PLANNING COMMISSION REGULAR MEETING AGENDA

Subject: 313 South Street Building Additions; Site Plan Review; Revised Plan dated 8/6/2025.

Subject: 120 S. Main Medical Office; site plan and special projects review #1; Revised Site plan and elevations dated 8/1/2025, plus supplementary information.

LS1.1

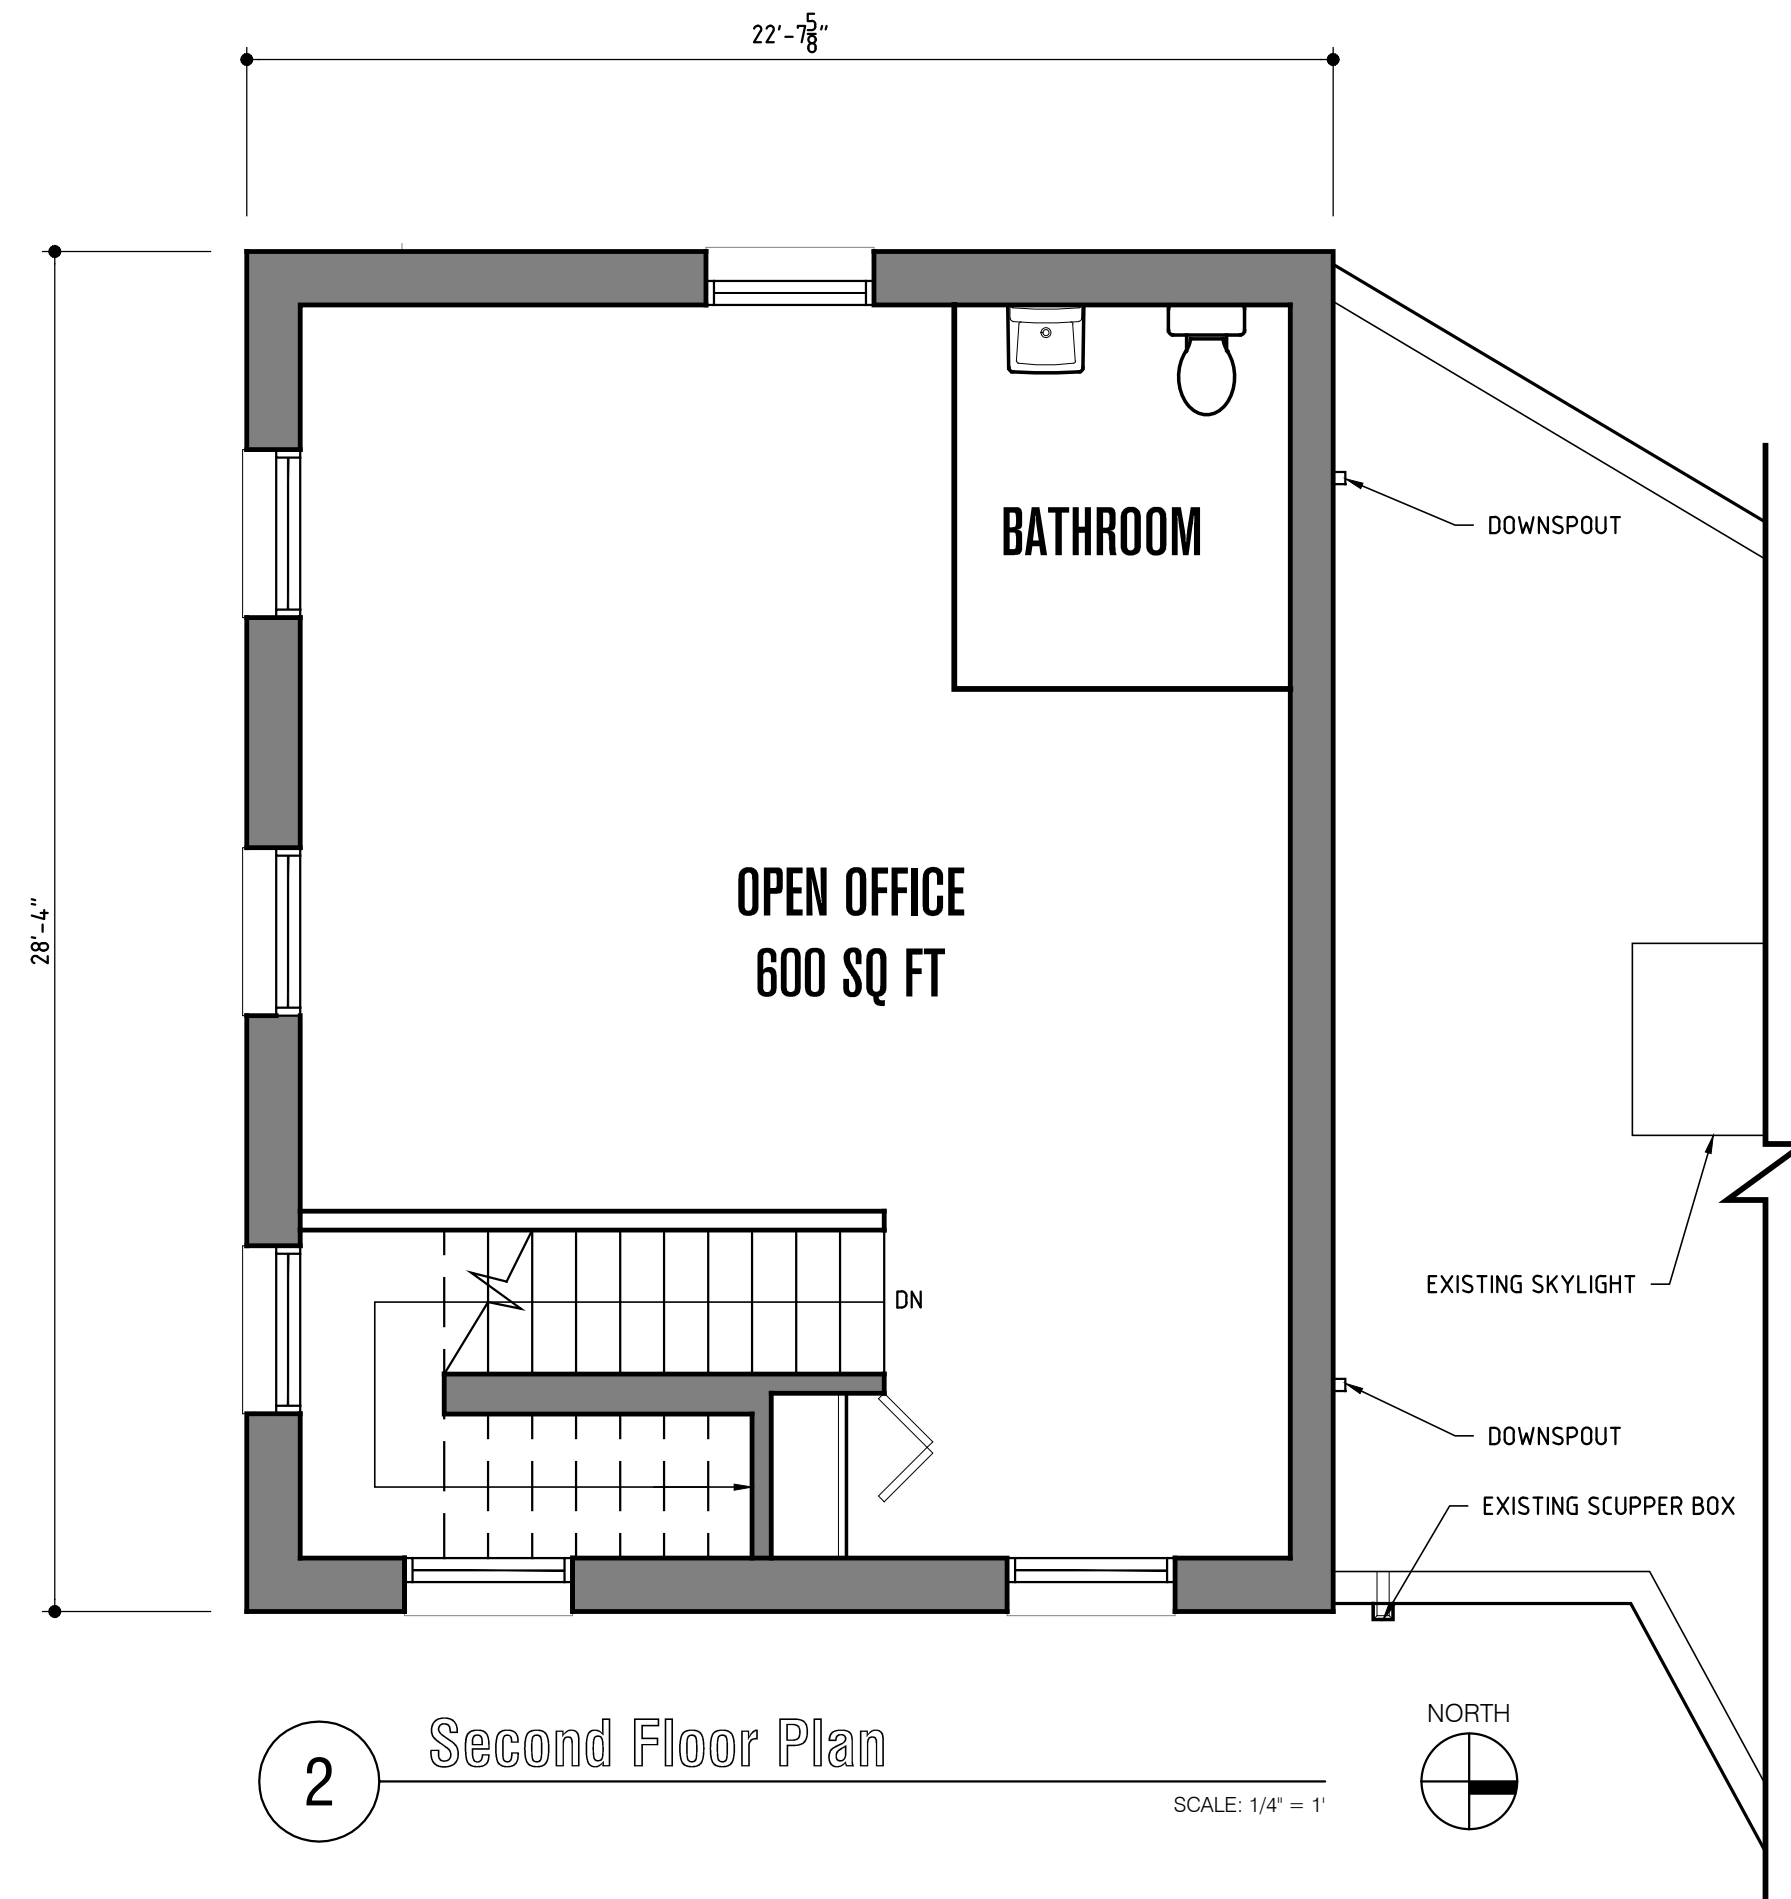
The site is located entirely within the 100-year floodplain; therefore, the plan notes that compliance with the 30’ wide required landscape stabilization zone on the north side of the site along the Clinton River is not possible. A variance from this provision was granted by the Zoning Board of Appeals on June 25, 2025.
